RESPONSE TO REQUEST FOR ADDITIONAL INFORMATION

APR1400 Design Certification

Docket No. 52-046

RAI No.: 409-8325
SRP Section: SRP 19
Application Section: 19.1
Date of RAI Issued: 02/22/2016

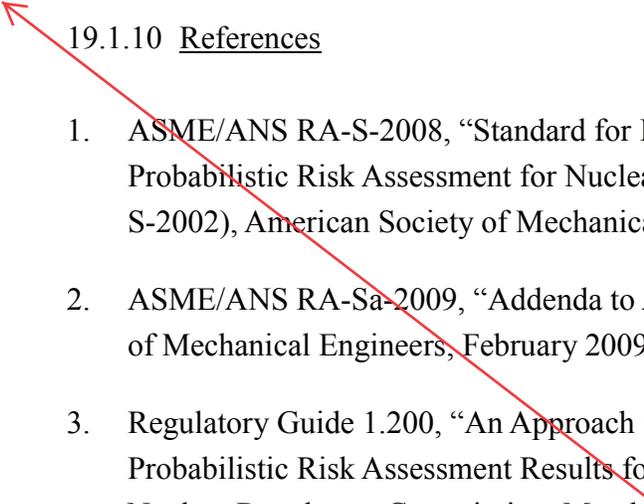
- a. In the APR 1400 design, the staff understands the charging pumps are not automatically loaded on the EDGs. The operator must manually reload the charging pumps onto the EDGs and restart the pumps for deboration to continue. The staff is requesting this clarification to be added to Section 19.1.6 of the design control document (DCD).
- b. The staff is requesting the applicant to add in Section 19.1.6 of the DCD the procedure or guidance that prevents the operator from restarting the charging chemical and volume control system (CVCS) pumps and thus preventing reactor coolant system (RCS) deboration from continuing.
- c. The staff is requesting a justification to be added in Section 19.1.6 of the DCD as to why boron dilution events were screened from the low-power shutdown (LPSD) PRA. If operator actions are important in screening the risk of boron dilution events from the

PRA, the staff is requesting that these operator actions be added to the risk insights Table 19.1-4 or provide instead a justification as to why this addition to the risk insights table is not necessary. In addition, please consider whether a COL item should be added to section 19.1.6 of the DCD.

- a. This clarification will be included in DCD Section 19.1.3.1.f as shown in Attachment 1.
- b. This clarification will be included as an additional COL item in DCD Section 19.1.9, and the associated COL Table 1.8-2 will be revised as shown in Attachment 2.

The ACP is powered by the safety-related buses which are normally supplied by Class 1E onsite or offsite power. Following a Loss of Offsite Power, the buses will be re-energized by the emergency diesel generators. However, the ACP will not automatically re-start. It needs to be manually re-started by the operators after bus voltage has been restored.
